Butte Priority Soils Operable Unit (BPSOU) Final Insufficiently Reclaimed (IR) Sites Field Sampling and Investigation Plan (FSP) Butte Remediation Evaluation System (BRES) No.174 – Buffalo Ditch

RE: Butte Priority Soils Operable Unit (BPSOU) Final Insufficiently Reclaimed (IR) Sites Field Sampling and Investigation Plan (FSP) Butte Remediation Evaluation System (BRES) No.174 – Buffalo Ditch

**Re: Approval letter for the Butte Priority Soils Operable Unit (BPSOU) Draft Final
Insufficiently Reclaimed Sites – Field Sampling Plan (FSP) BRES No. 174 – Buffalo
Ditch (dated July 25, 2023)**

FIGURE 1

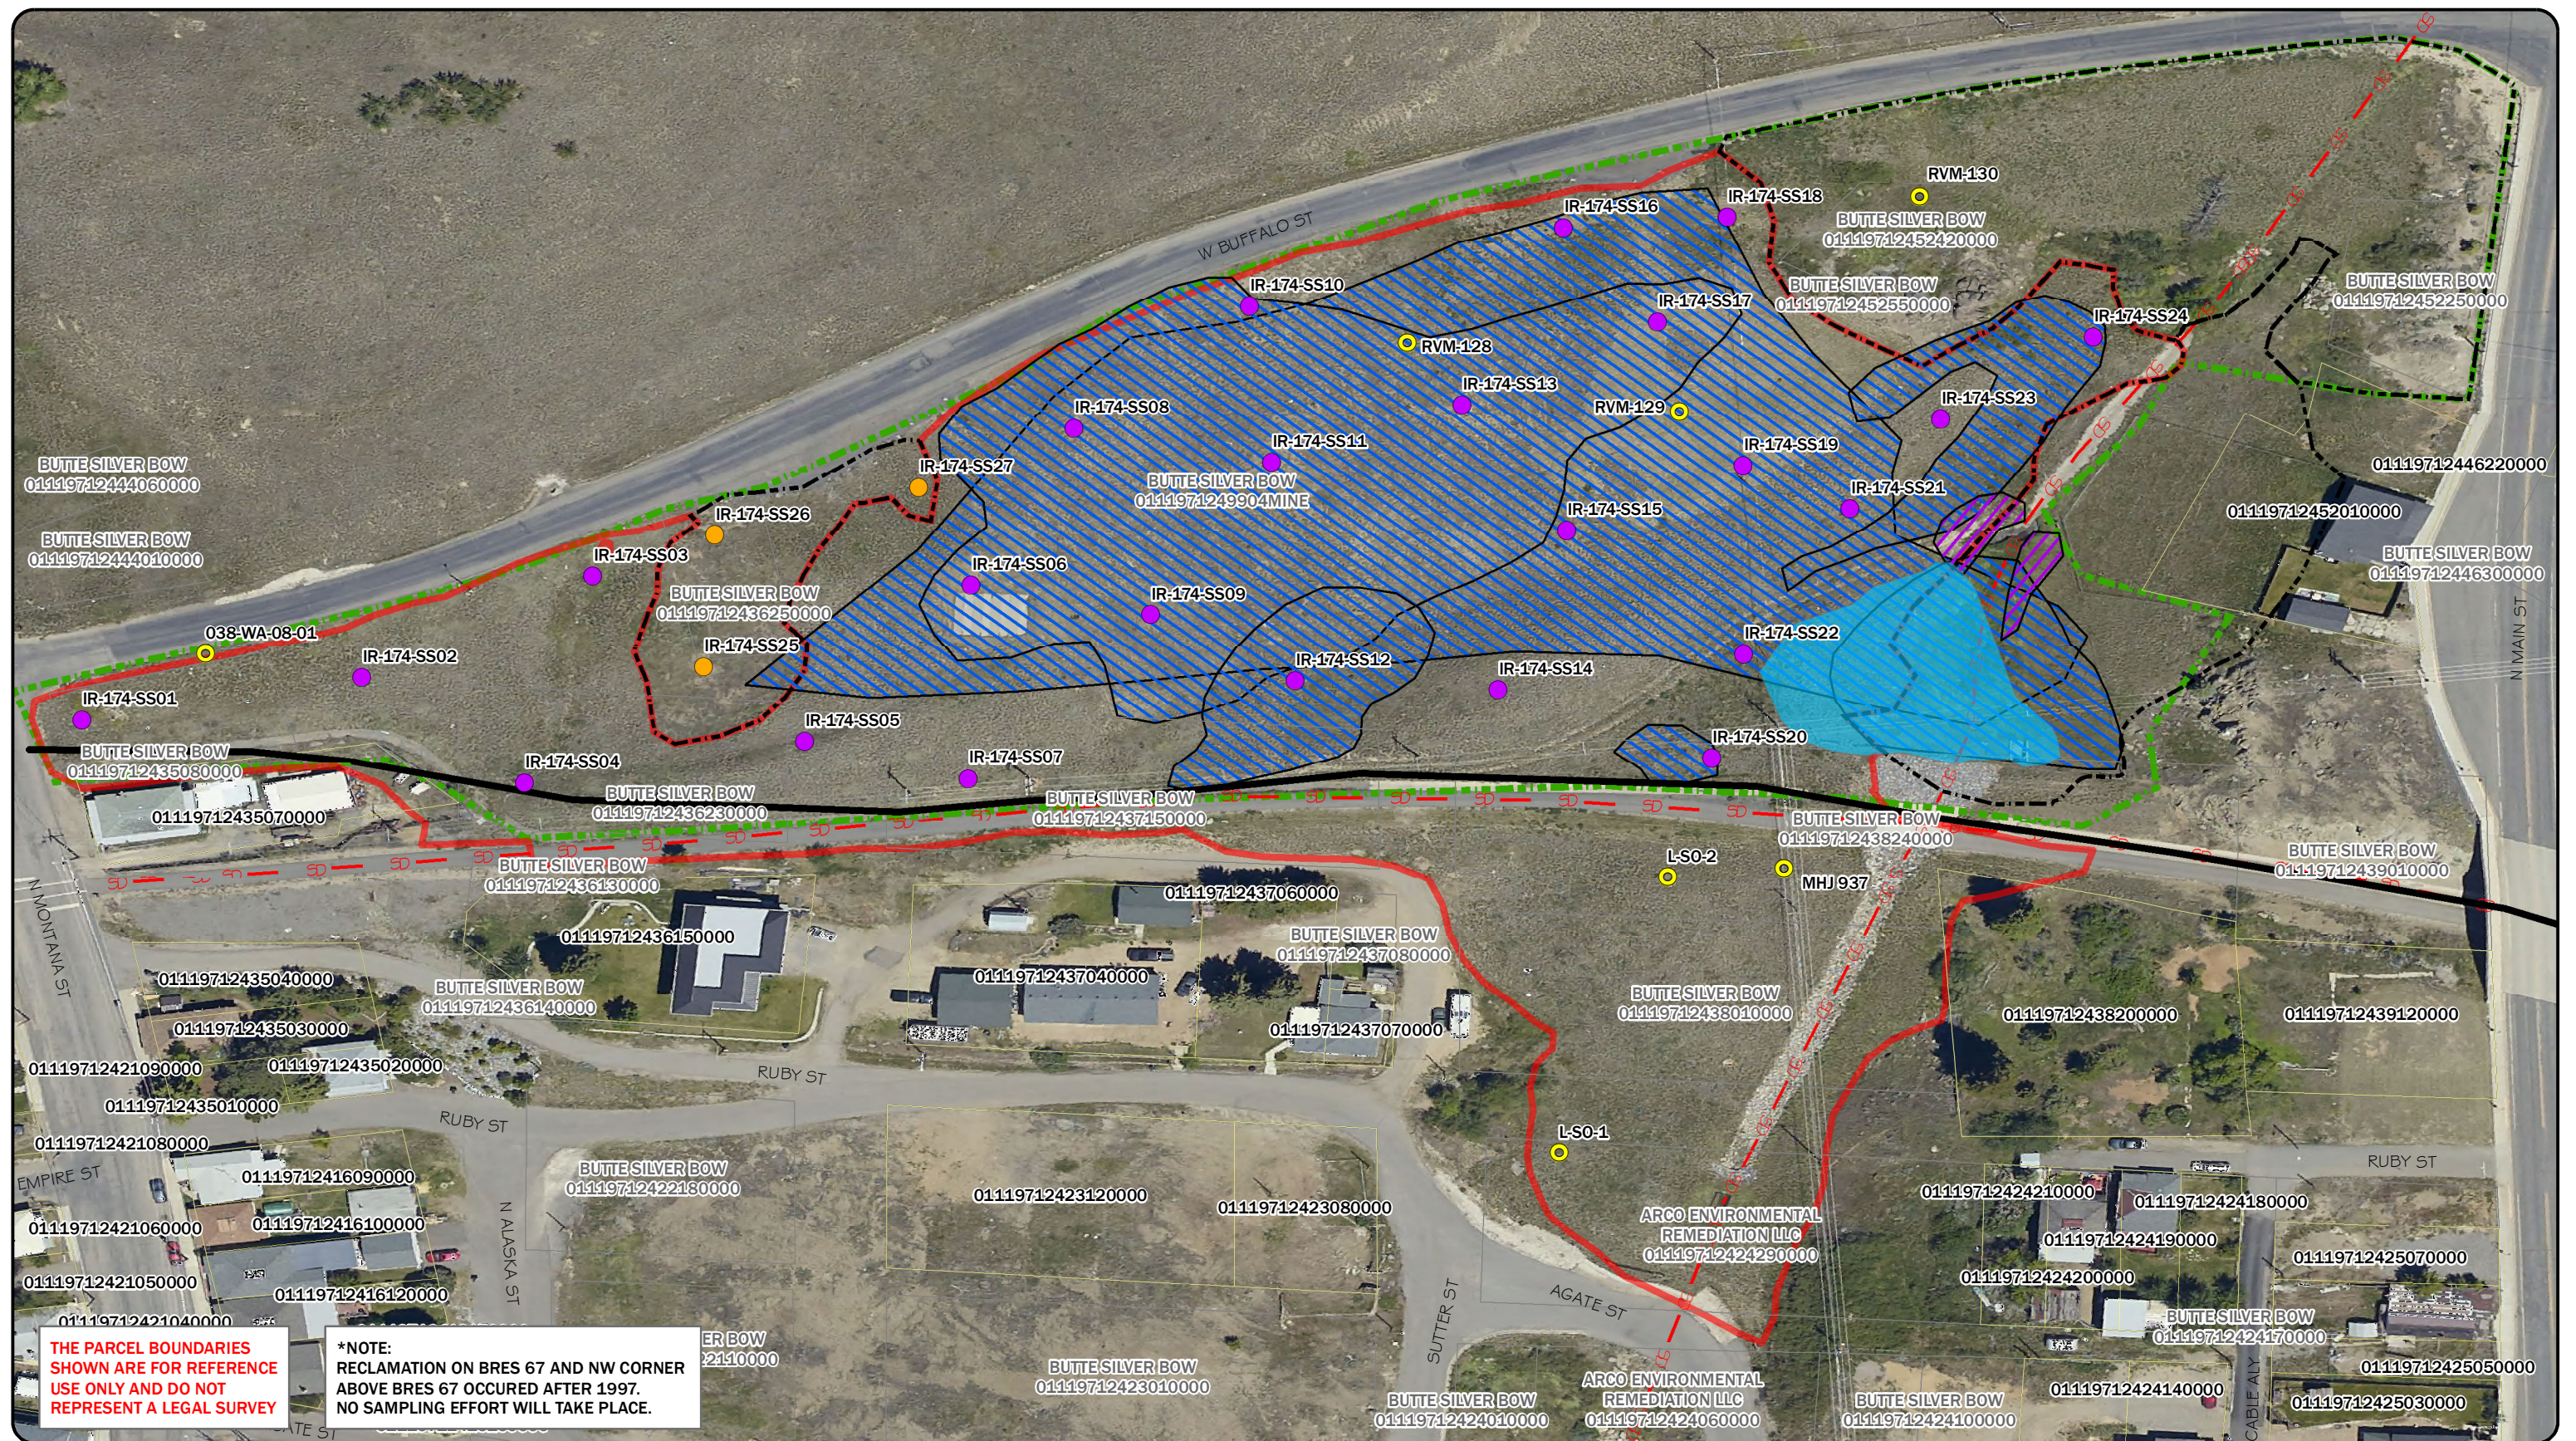
2. *Figure 1: Please confirm that sample 038WA08-0 is included on the Figure 1.*

Atlantic Richfield Response: Figure 1 has been updated to include the sample referenced. During revision, sample identification for this historical station was revised to "038-WA-08-01". Although review of available historical data includes samples collected on adjacent sites, for consistency historical sample data presented in this revised and final FSP includes only historical sample data points within the original sampling boundary or the proposed boundary adjustment.
